## ON-SITE SEWAGE DISPOSAL SYSTEM HOWARD COUNTY HEALTH DEPARTMENT BUREAU OF ENVIRONMENTAL HEALTH

SUBDIVISION: Middle Trail Estates LOT NUMBER: 19D

ADDRESS: 16357 Old Frederick Rd/ Edward Ln PROPERTY OWNER: Tatum

TOTAL ABSORPTION AREA SYS I =  $700 \text{ ft}^2$  / 10357 OLD Fred.

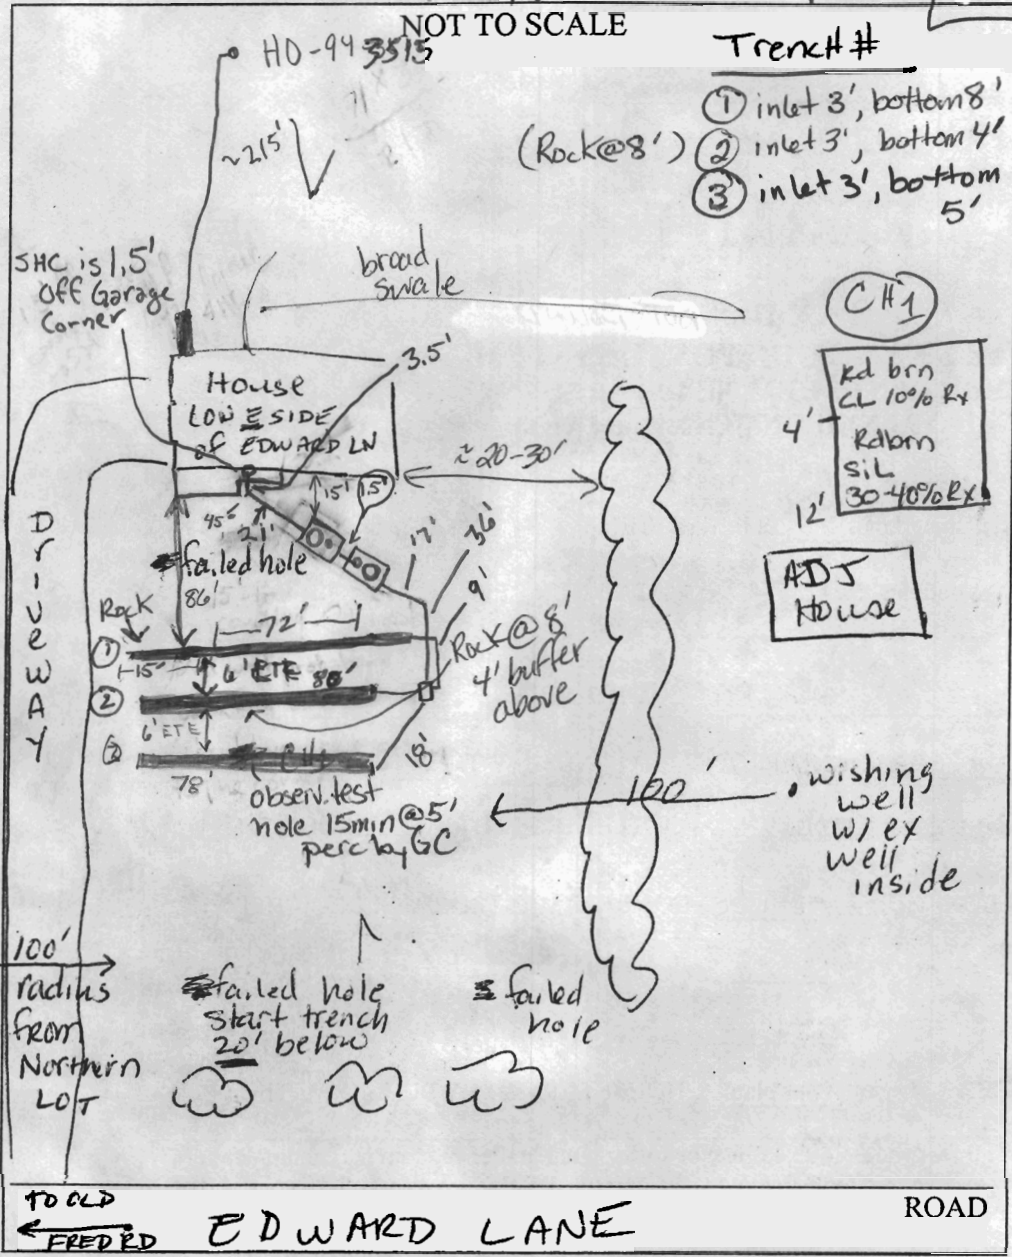
*No ↑ in bedrooms due to poss areas of rock in 2nd system. (KN)*

- ① inlet 3', bottom 8'
- ② inlet 3', bottom 4'
- ③ inlet 3', bottom 5'

(Rock @ 8')

410-489-4457  
 PRE-CONSTRUCTION 6/2/05 Contractor to call surveyor. Well radii measured & marked for adj. lots, cable line marked & failed holes identified.  
 INSTALLATION Contractor to call when opening trenches (KRI Inlet @ 4 1/2').  
 IF CH1 supports 8' bottom trenches, with 4' tx zone avail, may deepen trench #1 (highest) another 6" 6/2/05 Cleanout to be on SHC @ inside wall. 3.5' coming out of house 45° to a 15' piece coupled to a 6' piece (21) Bill will prob. be backfill HC to allow bricklayers access to the corners. Tanks to be filled around sides but not covered. Dug test hole and rates were ok. (GAC) 6/6/05 Pockets Rx possible; found @ last 15' of trench #1 (driveway side); no pipe last 15', Trench #2 perc @ 8' 5gal less 1 min, soil above ok.  
 FINAL INSPECTOR Schulz A. Criverton DATE OF APPROVAL 9/26/05  
 3rd trench to be installed later this week. OK to cover well here, however, Seal @ house. (KRI) 6/21/2005 3rd trench ok. Told Bill to put T cleanout before D-Box. (GAC) Alarm OK (Circuits 9 & 11) 2 pumps O.K. (GAC)

16357 OGD Fred.

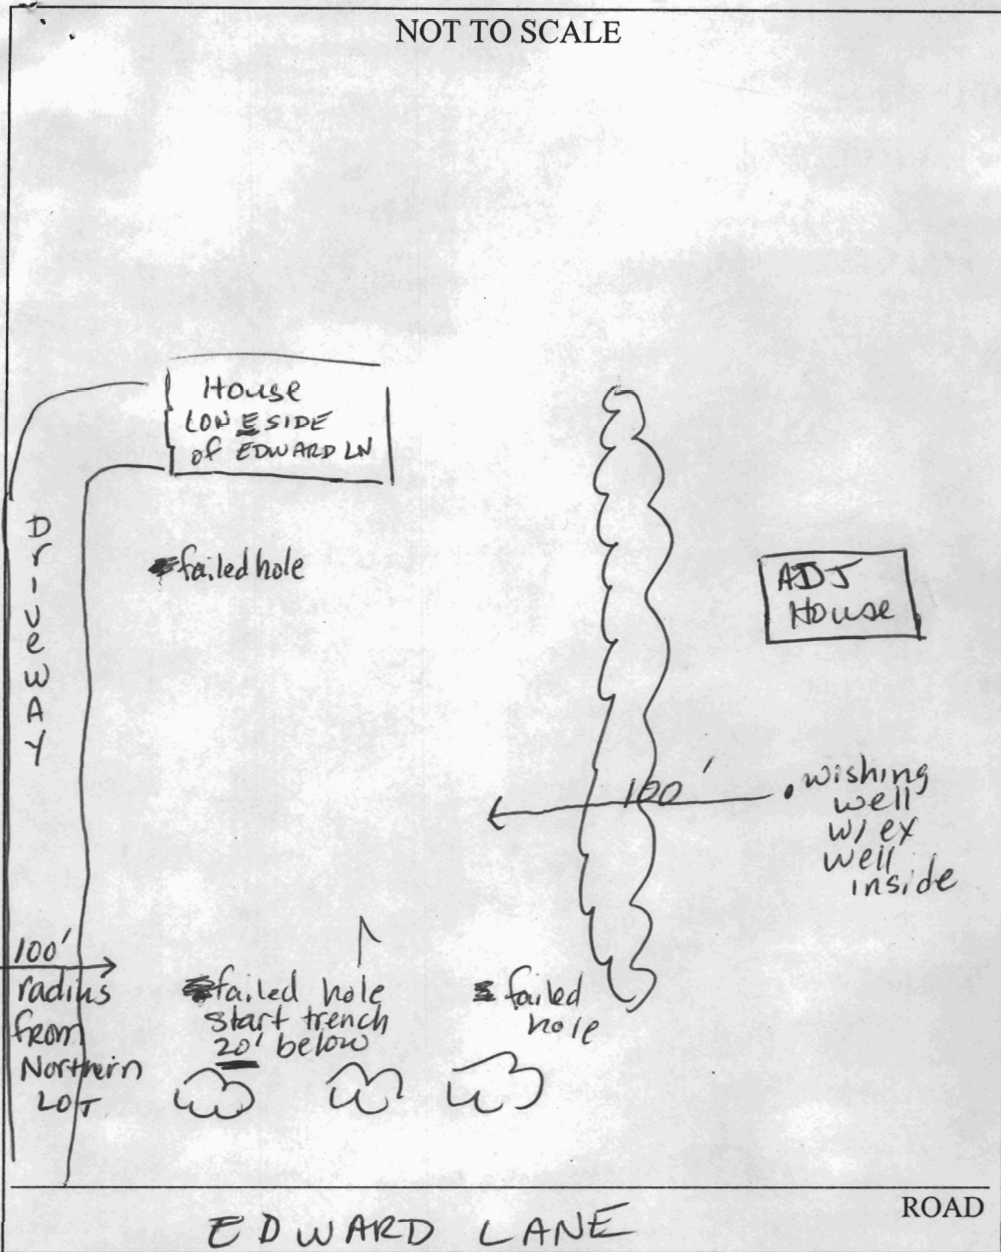
*630ft<sup>2</sup> absorption  
reg'd*

410-489-4457  
 PRE-CONSTRUCTION 6/2/05 Contractor to call surveyor. Well radii measured & marked for adj. lots, cable line marked & failed holes identified.  
 INSTALLATION Contractor to call when opening trenches (K) Inlet @ 4 1/2".  
 IF CH1 supports 8' bottom trench, with a 4' tx zone avail, may deepen trench #1 (highest) another 6"

FOUNDATION LOCATION DRAWING  
LOT 19D  
PROPERTY OF  
**ROSS S. & DEBORAH L. TATUM**

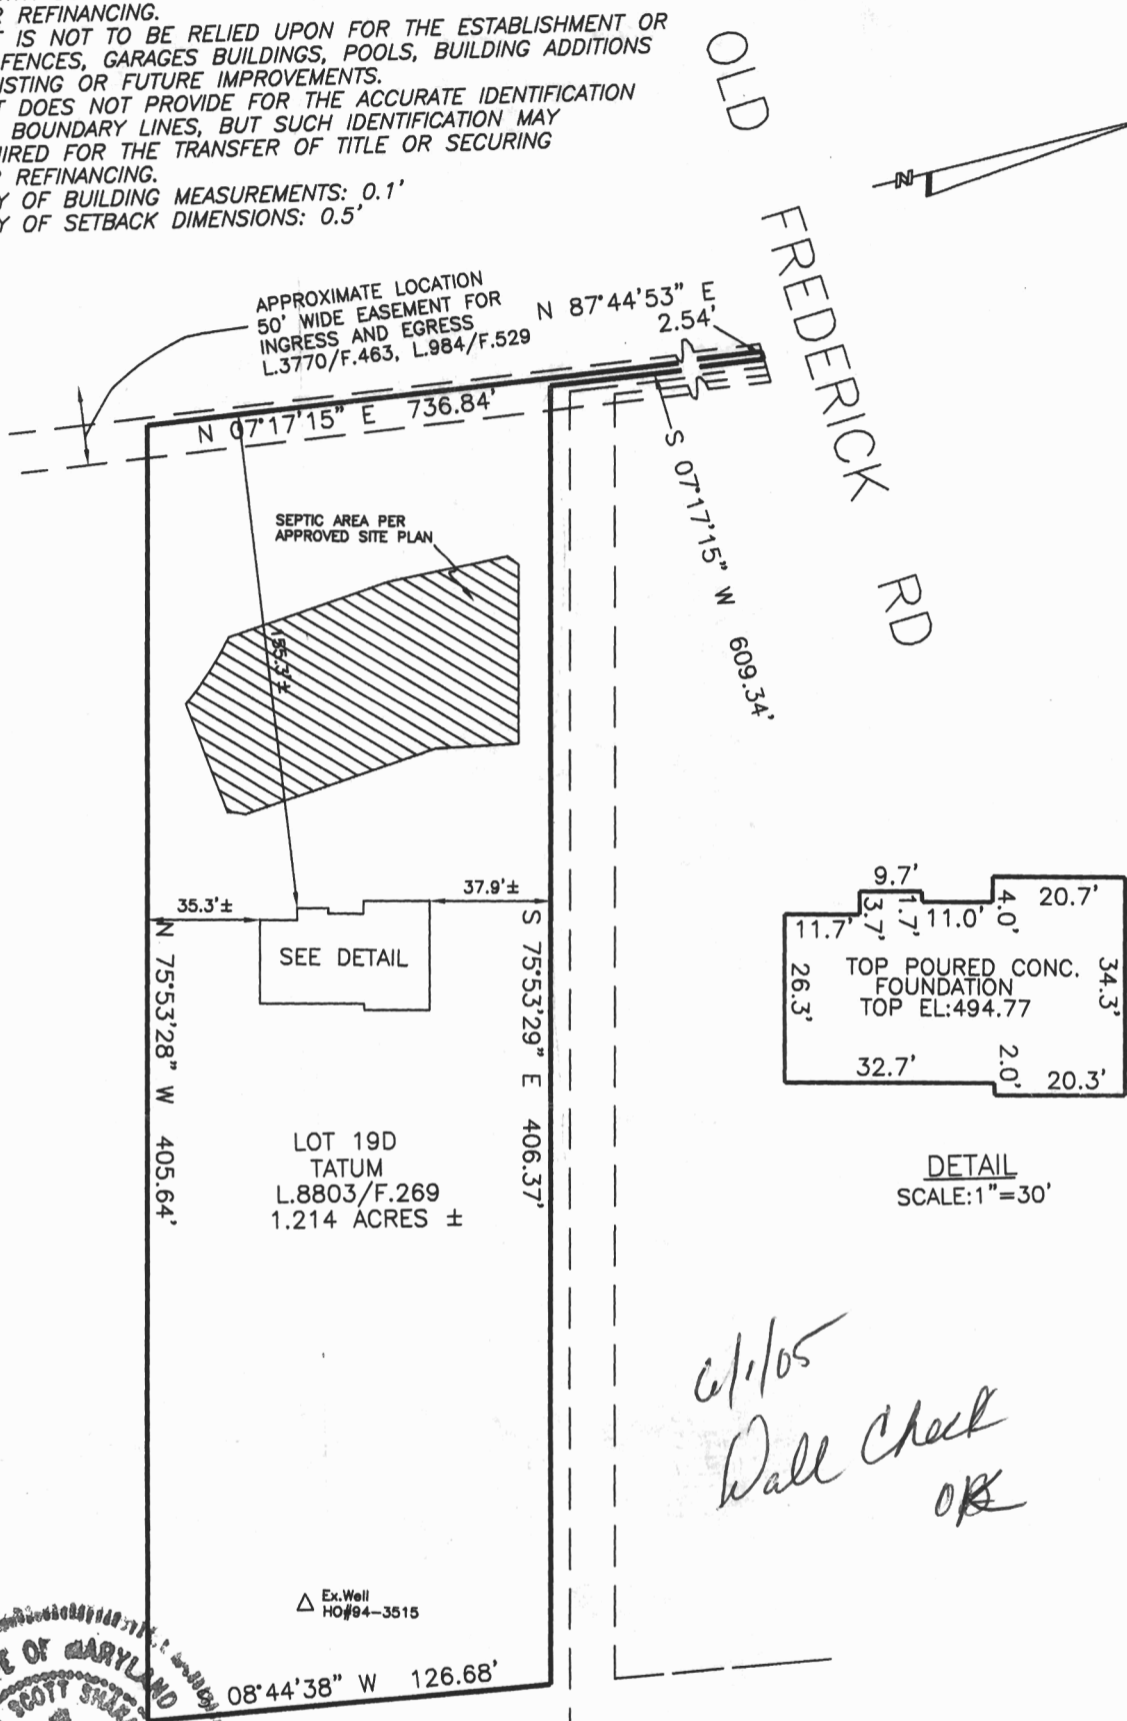
*6/1/05*  
*Wall Check*  
*OK*
